CONSTRUCTION VALUE ENGINEERING CHANGE PROPOSAL
MISSOURI DEPARTMENT OF TRANSPORTATION

Contract ID 080229-X01 Job No. JOP0931 Date 15 AUG 08
County Wayne Route US67 Original Bid Cost \$35,413,759.63
Contractor Flynn Company, Inc. By Mike Flynn
Designed By Dan Streicher / Steve Bubanovich Phone 563.556.5334

VECP 08-72

RTE. US67 CO. WAYNE LOC. Sta 736+02.5 AUTHOR SH
JOB NO. 080229-X01 SUBJECT VECP #1 - RE SUBMITTAL CHK.

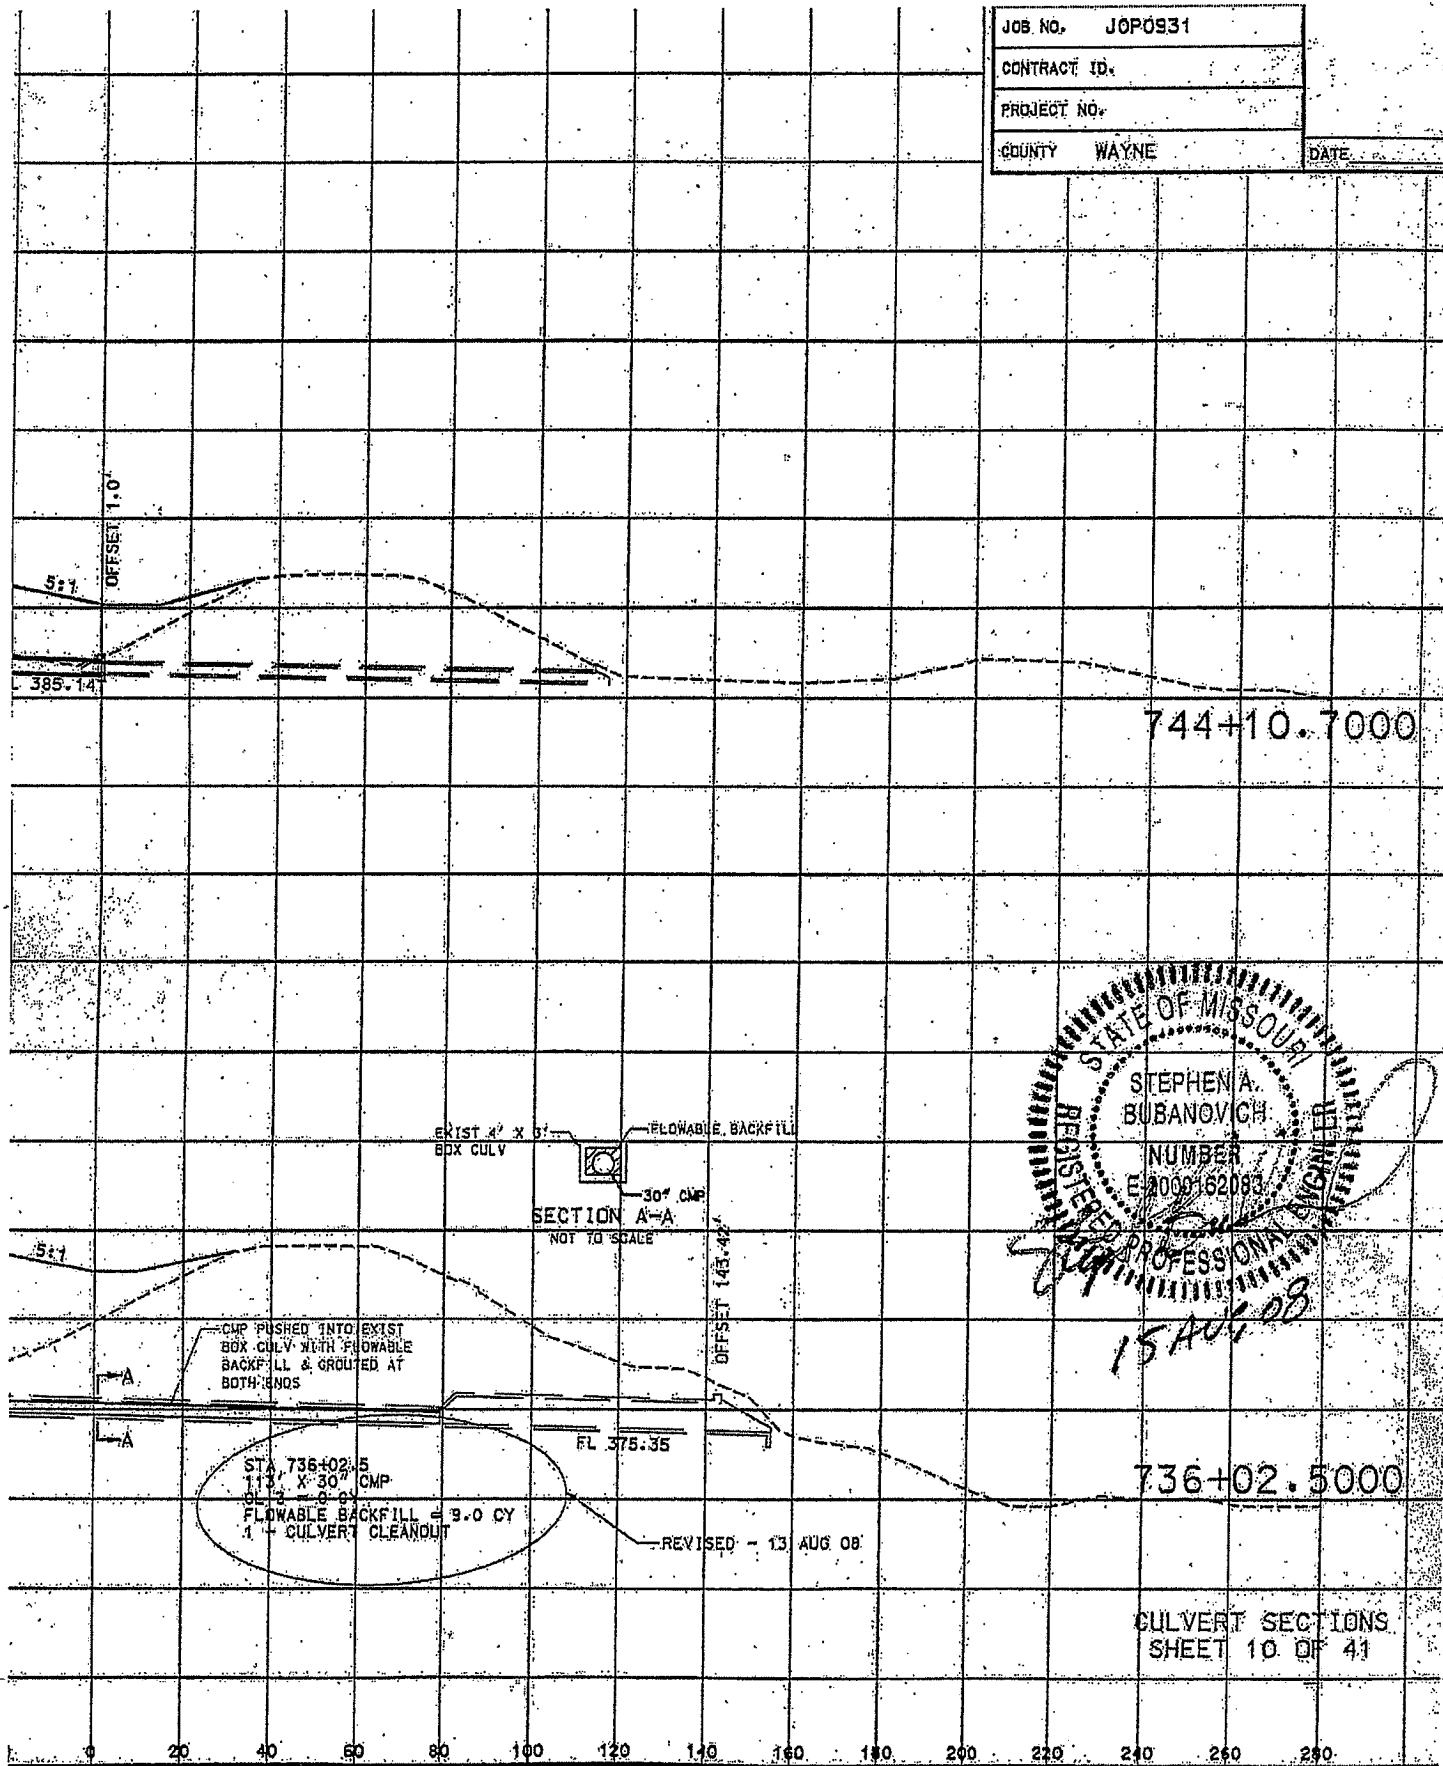
This proposal was originally submitted with the intent of eliminating both the flowable backfill and CMP pipe inserts at existing box culverts at stations 880+26 and 736+02.5, and was denied based on earlier structural analysis.

Further review and discussions have revealed a portion of the proposal is acceptable for the installation at station 736+02.5. The downstream portion of this culvert, an 8X6 RCB, is in very good structural shape, exhibiting no visible cracking, spalling, or other problems. This portion of the culvert will not be subjected to additional loadings and therefore will not need the additional structure reinforcements contained in the original design.

We have revisited this matter and have made a decision to incorporate part of this VECP. Tammy Hefner and I evaluated the existing structure at station 736+02.5 and found it to be in very good condition. We have made a field change, with Designs' approval, to eliminate the pipe and flowable backfill on the 8X6 portion of this culvert.

I have attached a revised submittal of this previously denied VECP. The revision asks for the contractor to be allowed to capture 25% of the savings in a Practical Design VE proposal. I have included a cost breakdown and revised drawing showing the new features we are building at this location. I will wait for the completed VECP for prior to issuing a Change Order.

I recommend this revised proposal be accepted for the installation at Station 732+02.5 and the contractor be allowed to capture 25% of the savings as a Practical Design Value Engineering Proposal.

MODIFIED DESIGN

LINE 1080 - FLOWABLE BACKFILL
9.0 CY @ \$128.00/CY \$1,152.00

LINE 1140 - 30IN PIPE GROUP B
113 LF @ \$36.50/LF \$4,124.50
